KEYSTONE XL PIPELINE PROJECT - STEELE CITY SEGMENT PIPELINE ROUTE VARIATION FORM			
<b>1 VARIATION TYPE:</b>			
Refinement:	<input type="text"/>	Reroute:	<input checked="" type="checkbox"/>
Centerline:	<input checked="" type="checkbox"/>	Valve Site:	<input type="text"/>
		Pump Station:	<input type="text"/>
<b>2 LOCATION:</b>			
Sketch:	<input type="text" value="Attached"/>	Pictures:	<input type="text" value="See attached."/>
State:	<input type="text" value="SD"/>	County:	<input type="text" value="Harding"/>
Township:	<input type="text" value="20N, 19N"/>	Range:	<input type="text" value="4E, 5E"/>
Section:	<input type="text" value="33, 4, 3, 10, 11, 12, 13, 18, 17"/>	Centerline:	<input type="text" value="3/26/2010"/>
		MP:	<input type="text" value="308.76"/> to <input type="text" value="315.32"/>
<b>3 REASON FOR ROUTE VARIATION</b> (Please include reason for route variation):			
<p>This reroute is proposed to avoid paleontological features on the landowner's tracts on the current centerline near the MP 310.5 (David Niemi and Bret Clanton ML-SD-HA-01390, ML-SD-HA-01410, ML-SD-HA-01420, ML-SD-HA-11425).</p> <p>This reroute has been proposed based on field reconnaissance by a field eng

Trow	DATE	PROJECT	MAP PARAMETERS		
	Nov 12, 2010	50388X	PROJECTION: UTM 13, NAD83, US FT SCALE: 1" = 1,250', 1:15,000		
DRAWN BY	CHECKED BY	APPROVED BY	ROUTE VARIATION NUMBER	SHEET	REV.
ACB	CPA	WSF	0190-SD-P2-308.8-315.3-S	001	0

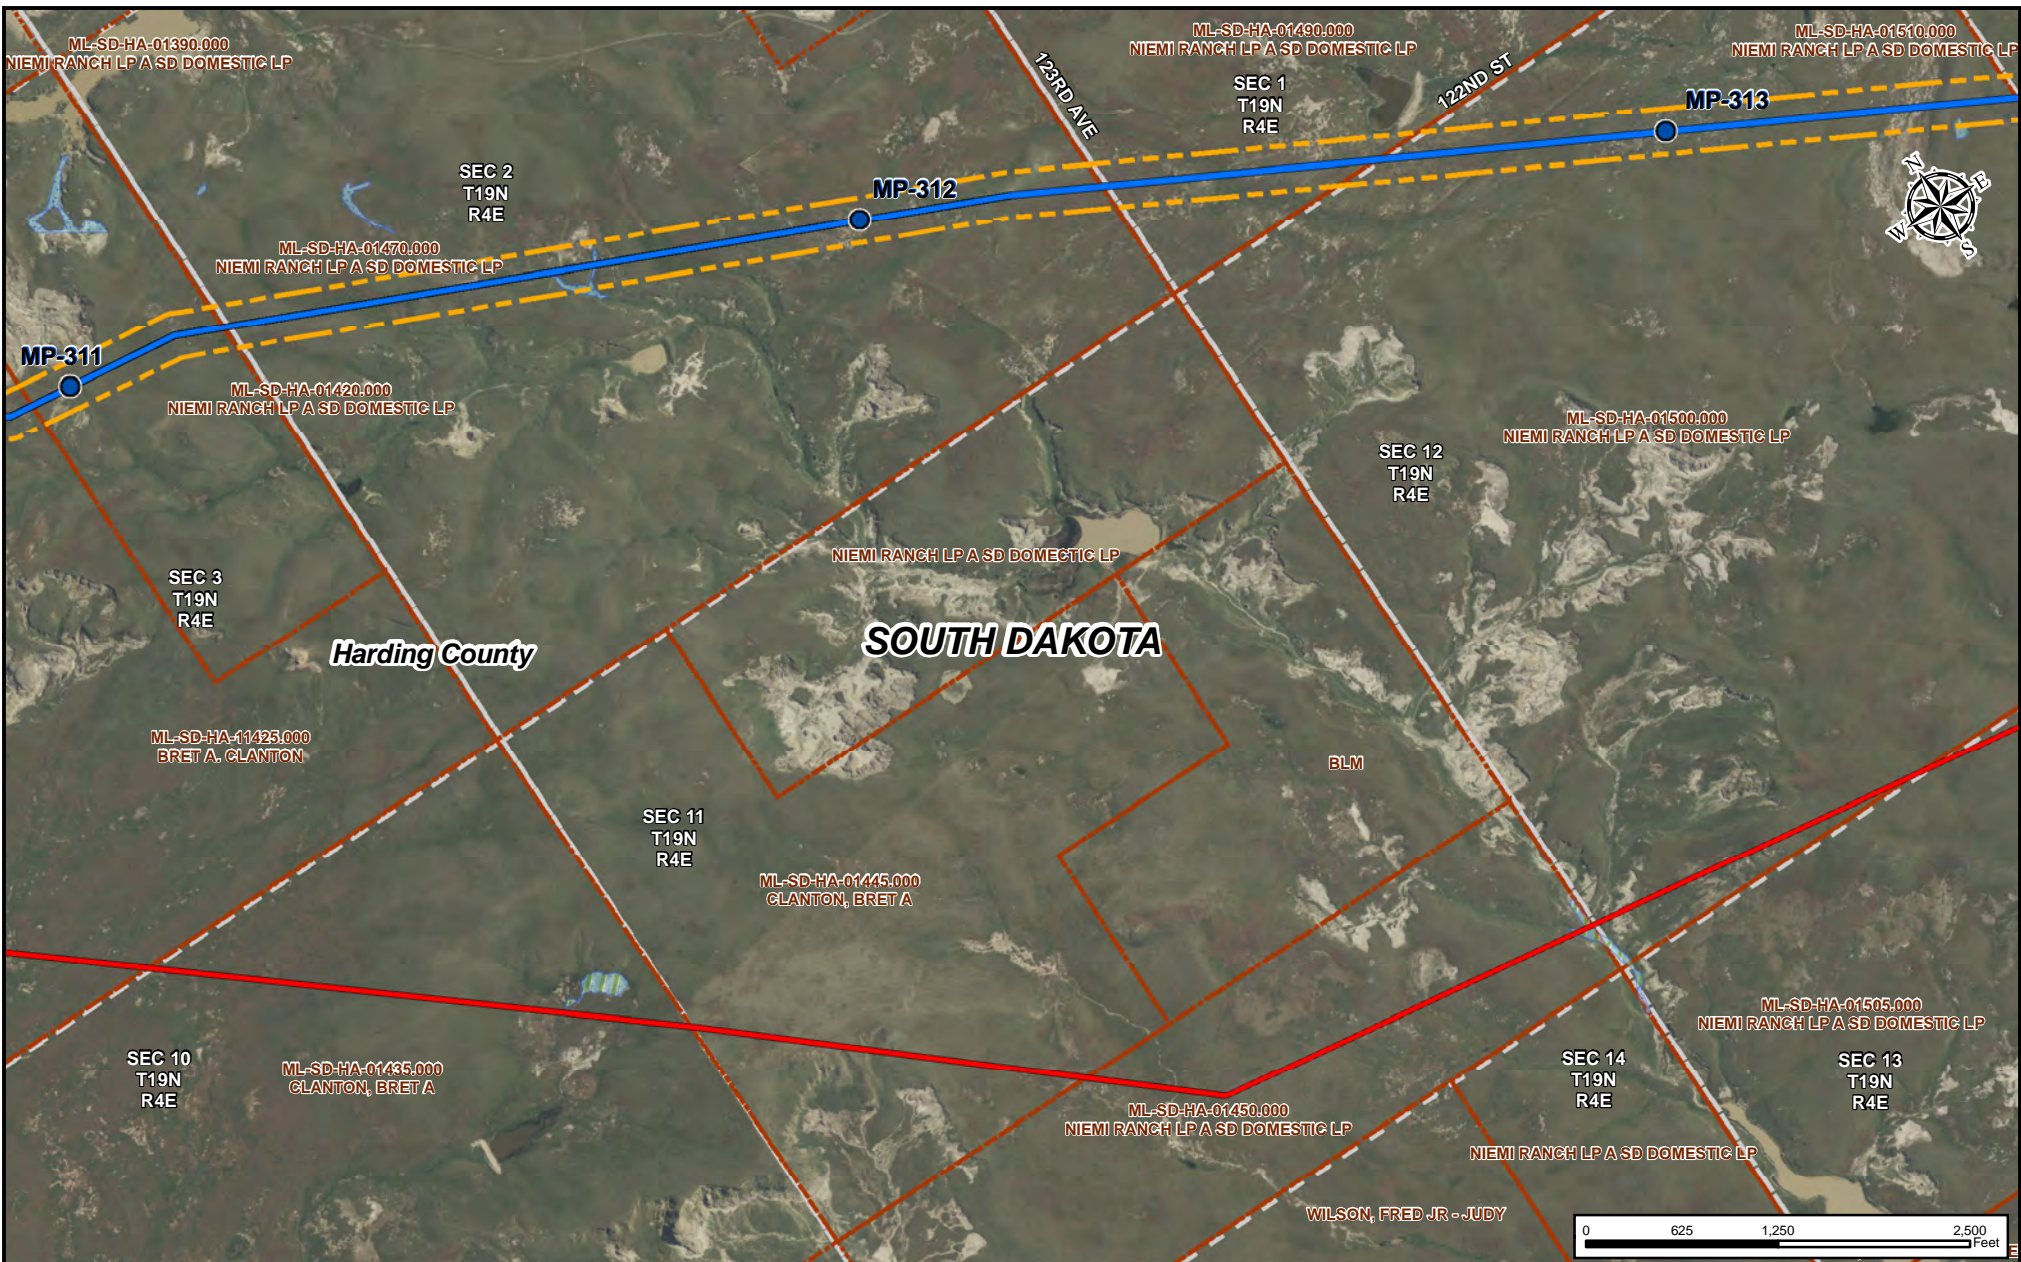
<b>DETAIL ROUTE VARIATION</b> (Please describe route variation in detail):			
<p>The proposed reroute starts at ~ MP 308.8 and deviates (~22°) away from the centerline towards the south. It continues in this direction for 4,460 ft to have a better creek crossing location and to avoid any construction impacts to what is referred to as an ancient shoreline with ongoing paleontological excavations to the east in Sections 33 &amp; 34, T20N-R4E and Section 3, T19N-R4E. From here, the proposed reroute turns towards the southeast, crosses a drainage feature and continues in this direction for 16,340 ft. This location is selected by the landowner to avoid any construction impacts to paleontological resources on this property. Along its path the proposed reroute accommodates the landowner's request and avoids the landowner's hay fields and waterlines in Section 10 &amp; 11, T19N-R4E. It then turns towards the east and continues for 14,060 ft before turning towards the southeast to rejoin the current centerline at ~MP 315.32. Along its path, it passes through some drainage features in Section 11 &amp; 12, T19N-R4E and crosses US Highway 85 approximately 1,640 ft south of its current crossing location.</p>

<b>ADDITIONAL IMPACTS</b> (Please include any additional impacts which may affect cost; crossings, induction bends, etc.):			
<p>The proposed reroute is ~2,430 ft longer than the original route and it adds an additional fitting to the centerline. The cost of material and installation of a single fitting is estimated to be \$30,000.</p> <p>The cost savings associated with avoiding the current paleontological excavations is very significant, a minimum length HDD to avoid a site would cost roughly \$1,000,000.</p>			
Is there an increase/decrease in the number of crossings?		Yes	No <input checked="" type="checkbox"/>
If yes, please list: <input type="text"/>			
<b>COST ANALYSIS</b> (costs incurred or saved from the route variation)			
Additional length of route realignment	<input type="text" value="2,430"/> ft.	\$ <input type="text" value="874,800.00"/>	\$ 360/ft
Additional length of side-hill construction:	<input type="text"/> ft.	\$ <input type="text" value="-"/>	\$ 19/ft

<b>Trow - Environmental</b> Jonathan Minton Comments: <input type="text" value="There are three paleo localities within the survey corridor of the Niemi reroute. All three are isolated finds that will require collection but do not warrant a route shift."/>	Variation: Approved <input checked="" type="checkbox"/> Rejected <input type="checkbox"/> <i>Jonathan Minton</i> Date: <input type="text" value="11/15/2010"/> If Rejected Why? <input type="text"/>
<b>AECOM - Risk Assessment</b> Heidi Tillquist Comments: <input type="text" value="This reroute increases the risk to a populated HCA and decreases the distance to groundwater HCAs. This reroute has a viable transport route to Buffalo. While not highly recommended, the route is permissible."/>	Variation: Approved <input checked="" type="checkbox"/> Rejected <input type="checkbox"/> <i>Heidi Tillquist</i> Date: <input type="text" value="11/15/2010"/> If Rejected Why? <input type="text"/>
